# CITY OF ALBUQUERQUE

**Re: Rockwell Office/ Warehouse**  
**1601 Airtech Ct SE**  
**Traffic Circulation Layout**  
Architect's Stamp 01-25-22 (N15-D010A)

Based upon the information provided in your submittal received 01-28-22, the above referenced plan cannot be approved for Building Permit until the following comments are addressed:

A TRAFFIC  
CIRCULATION  
LAYOUT  
SITE PLAN

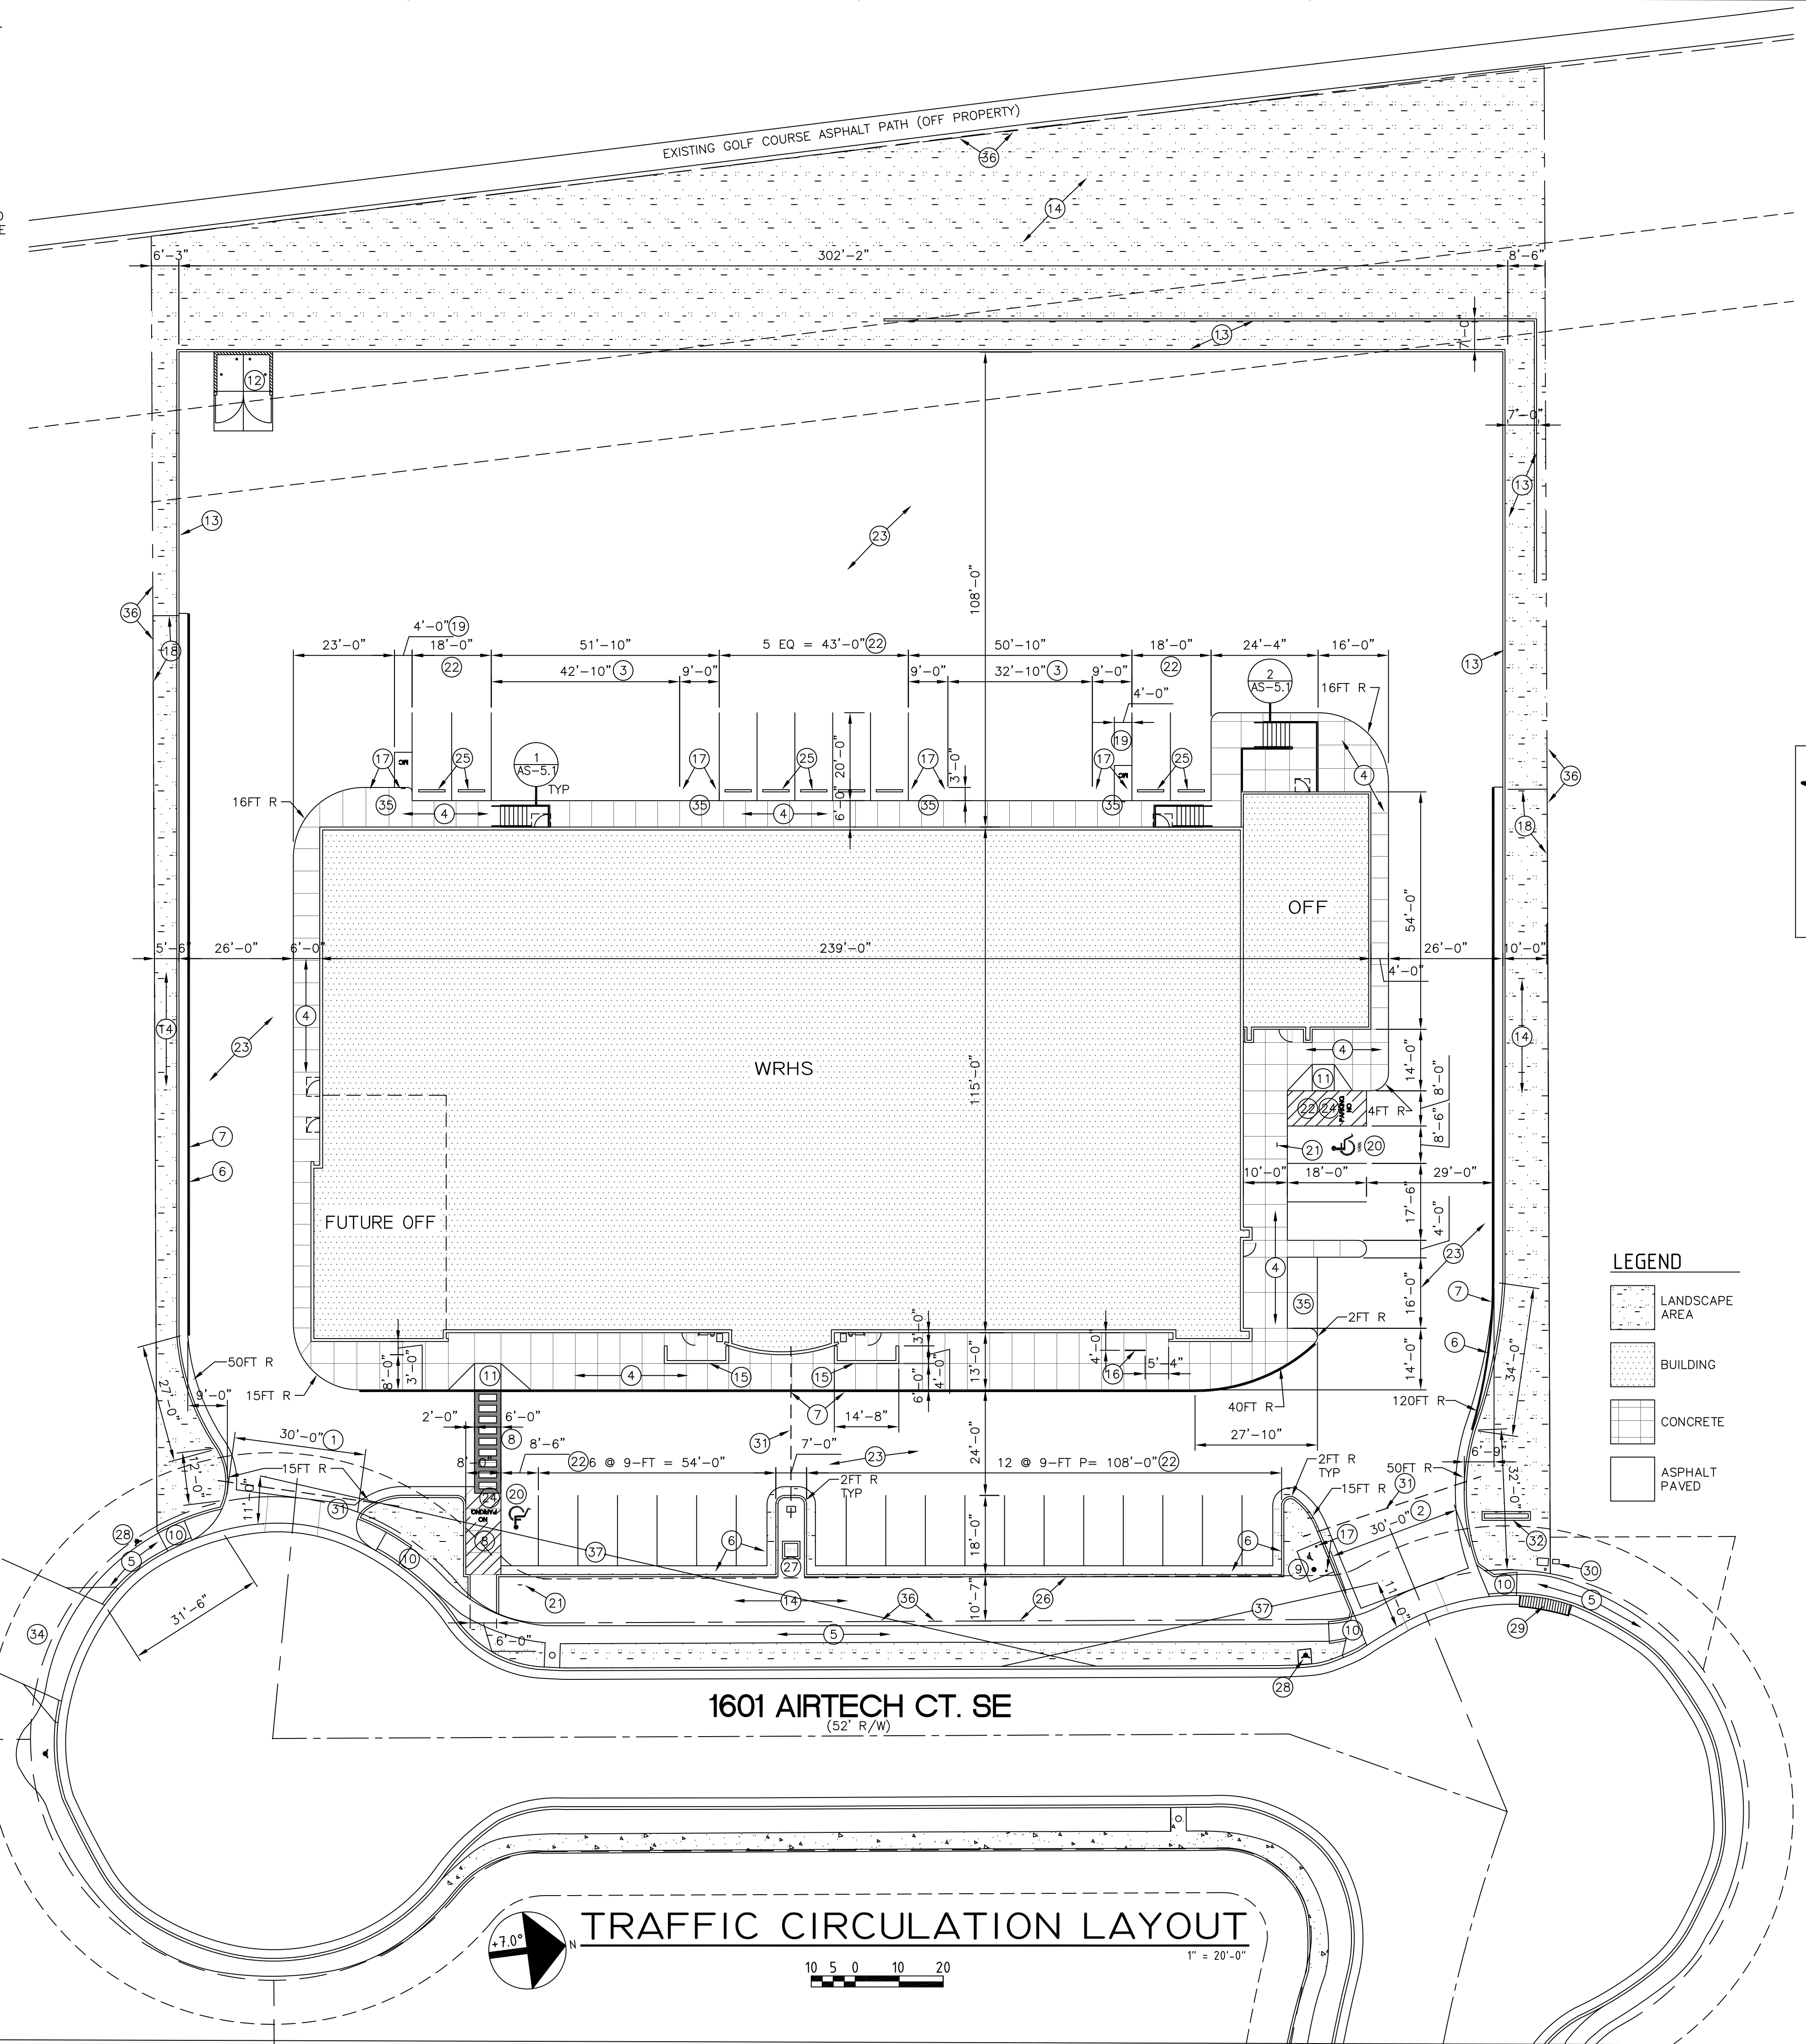
1. Key not 11: please call out COA std dwg 2442 A
2. Provide clear sight triangle dimensions on site plan.
3. Provide face sign details for the ADA signs, and Motorcycle parking spaces sign.
4. Provide a copy of Fire Marshal approval.
5. Please provide a letter of response for all comments given.
